SERVICE INSTRUCTION

RUNNING MODIFICATIONS ON

ROTAX® ENGINE TYPE 912/914 (SERIES)

SI-912-020R7

fig. 2

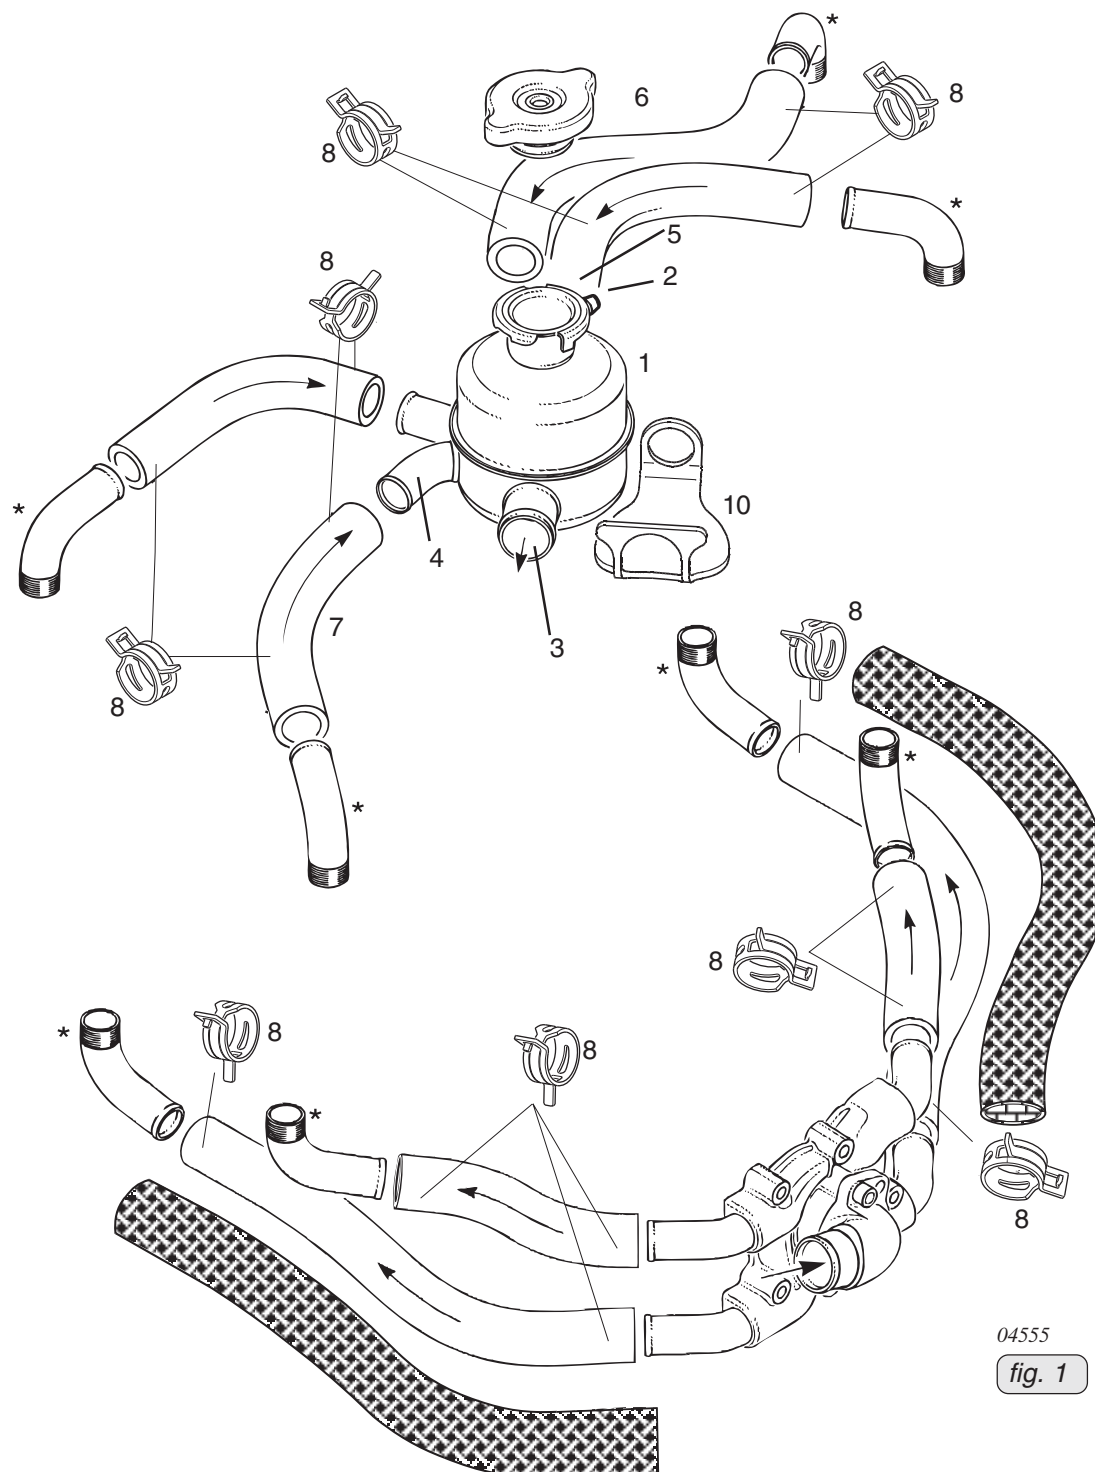
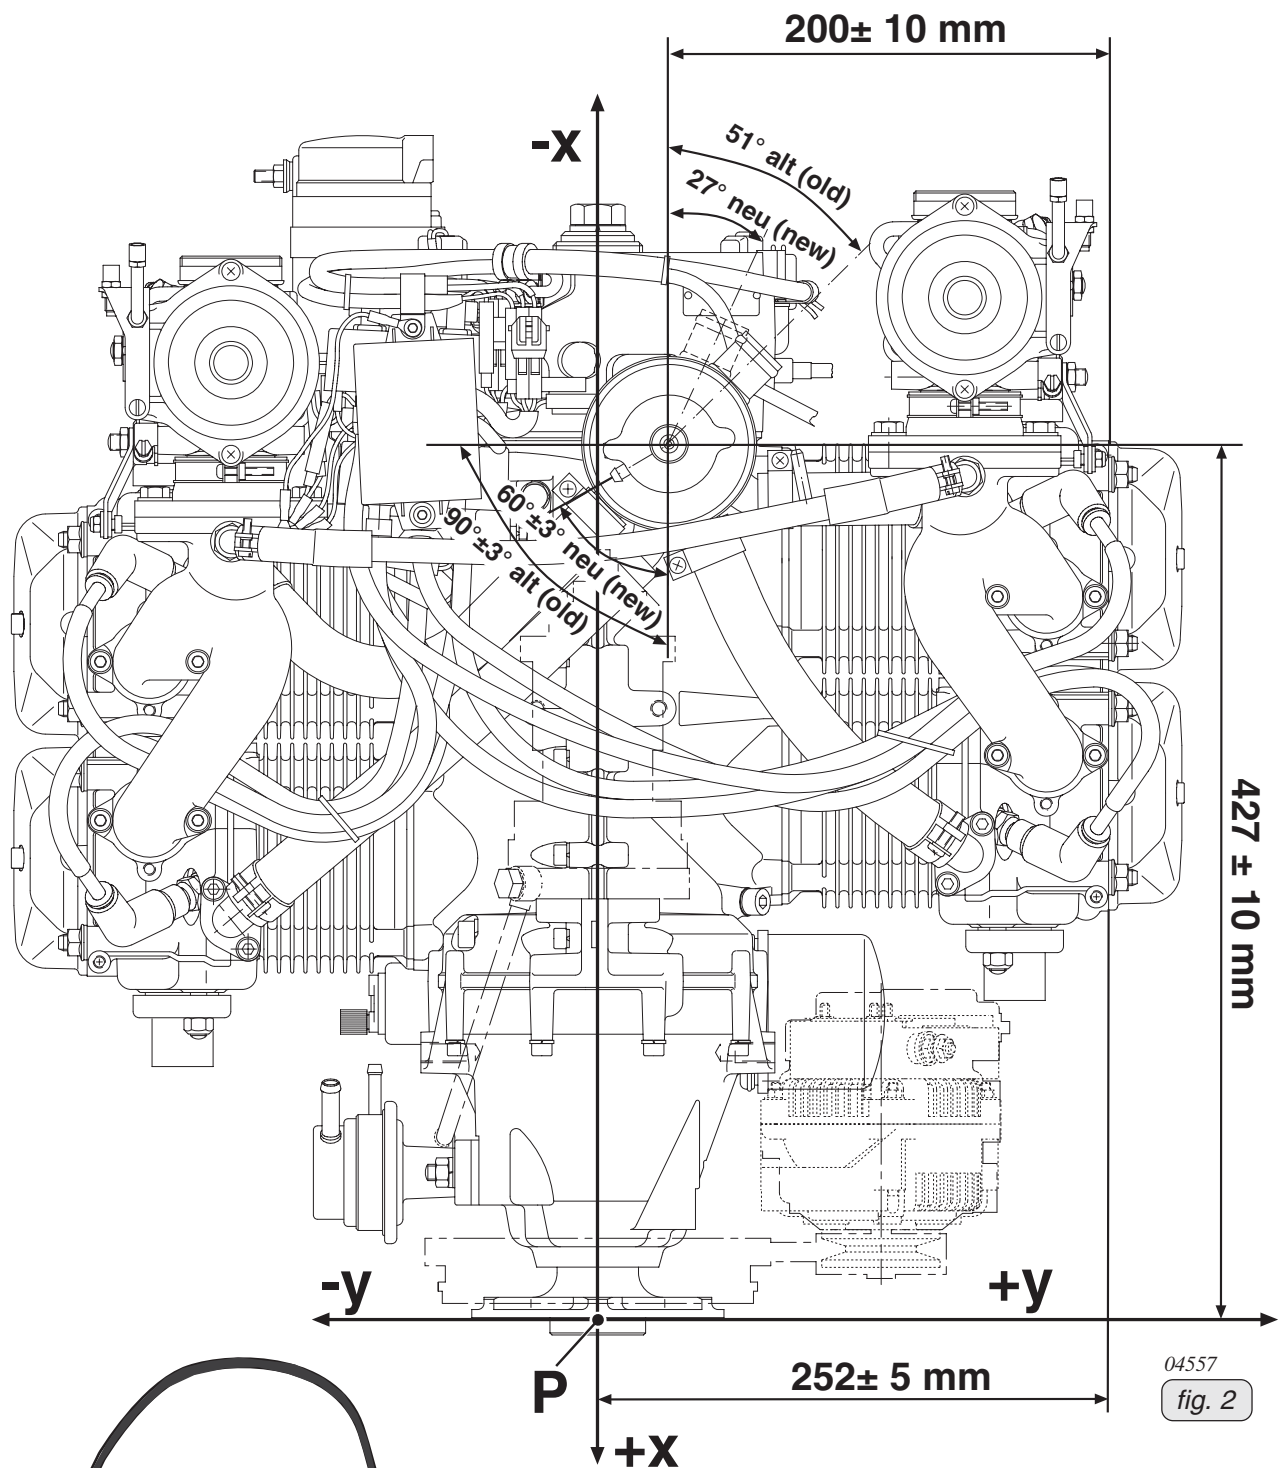
In the course of further development and standardization the position of the expansion tank (1) has been optimized!

- position of connection (2) to overflow bottle (from 0° to 30±3°)
- position of connection (3) to radiator (from 51° to 27±3°)
- angle of inlet socket (4) from cylinder 4 (34° inclined)
- length of inlet socket (5) from cylinder 3 (length increased by 13,4±3 mm)
- length of coolant hose (6) from cylinder 1 (length increased from 270 mm to 285 mm)
- length of coolant hose (7) from cylinder 4 (shortened from 100 mm to 85 mm)
- new spring type hose clamps (8) to attach the coolant hoses (expansion tank and water pump)

- Install the coolant hose (6) 285 mm to cylinder 1 and the new coolant hose (7) 85 mm to cylinder 4. For attaching all the coolant hoses from expansion tank, water pump, cylinders, use the new spring type clamps.

■ **CAUTION:** Take care of appropriate slip-on length of the coolant hoses on the corresponding connection socket. Verify tight fit of clamps and hoses and check for leakage. Always fit the clamps such that they can not wear on any component and use a suitable tool (see fig. 3) for fitting them.

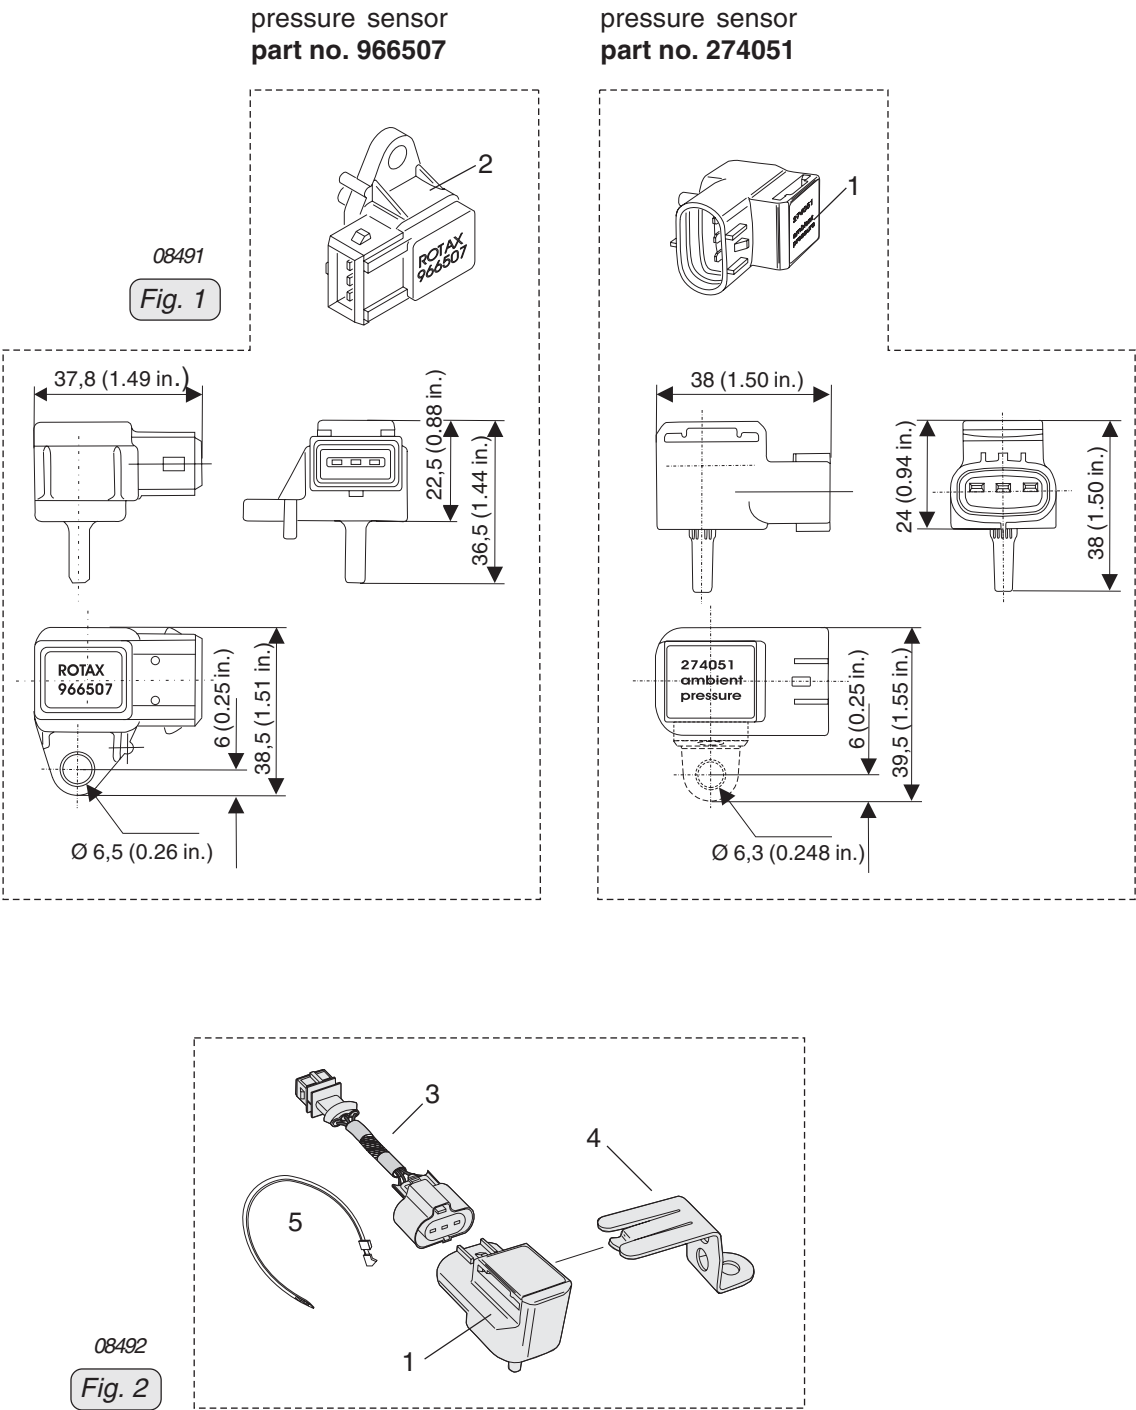
Due to the termination of production of the ambient pressure sensor (part no. 966507) a new ambient pressure sensor part no. 274051 has been introduced. The new ambient pressure sensor is of different size and also has a different connector. The connection for the wiring harness had to be changed.

1. Disconnect the pressure sensor (2) from the wiring harness.
2. Connect adapter cable (3) to wiring harness and to the new pressure sensor (1).
3. Install bracket (4) onto pressure sensor.

4. Position adapter cable and secure with cable binders (5).
